**RE: East Cell Spills 11-391 and 11-398**

The Snap Lake Environmental Monitoring Agency (SLEMA) has reviewed the Report on Snap Lake Spill 11-391 and 11-398 Monitoring Program, and would like to provide the Mackenzie Valley Land and Water Board (MVLWB) with the following comments.

**Figure 1. Water Levels in Sump #4 and Snap Lake**

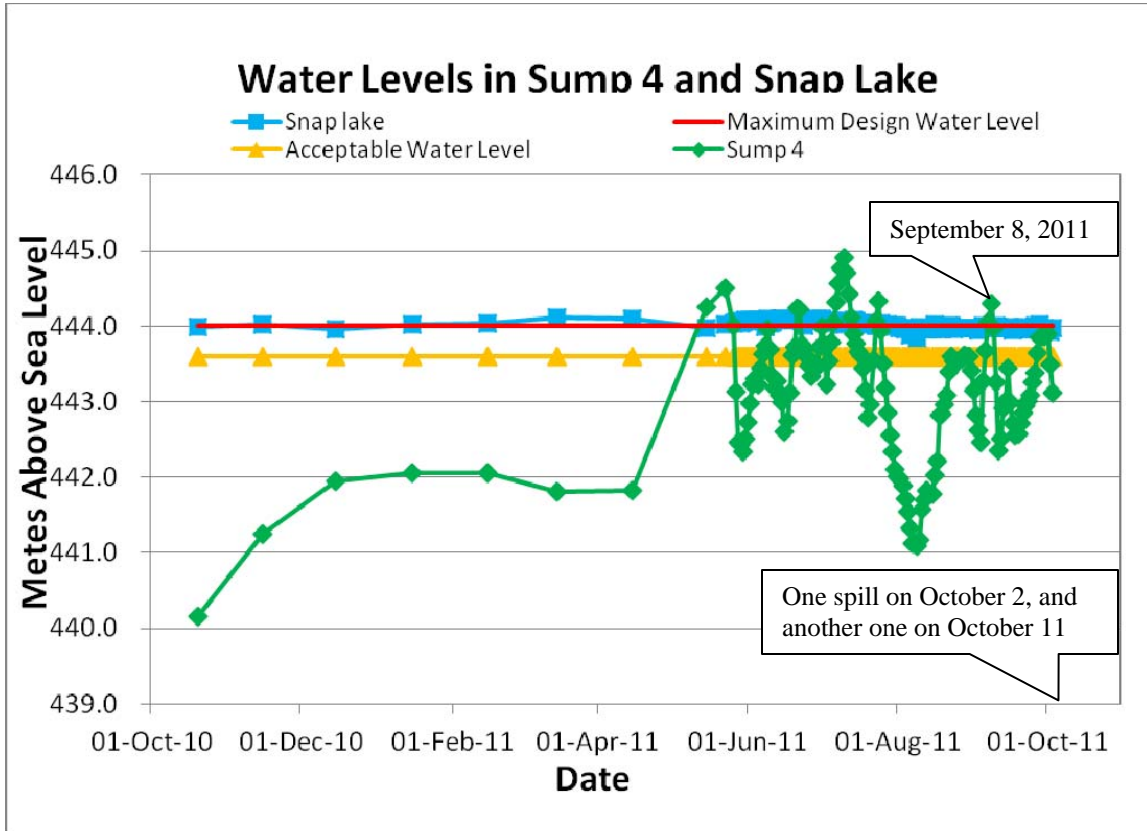
The two spills were preventable and should not be viewed as accidental. The following chart shows that since May 2011, the water levels in Sump #4 have been frequently above key water levels.

- 43 days that the acceptable water level of 443.6 meters above sea level (MASL) was exceeded.
- 17 days that the maximum design water level of 444 MASL was exceeded.

- 15 days that the water level was higher than the natural level of Snap Lake, against one of the design criteria of the East Cell Water Control Structures.

SLEMA staff observed water level in Sump #4 higher than that in Snap Lake on September 8, 2011 and asked for confirmation at the mine site on that same day and on September 15 during the Technical Session of Water Licence Renewal. However, the observation appeared to be ignored by De Beers.

- Current practices of water level control in the East Cell sumps appear to be deficient. Real-time water level control is recommended. It includes, but is not limited to, automated real-time water level monitoring and related dewatering schedule.
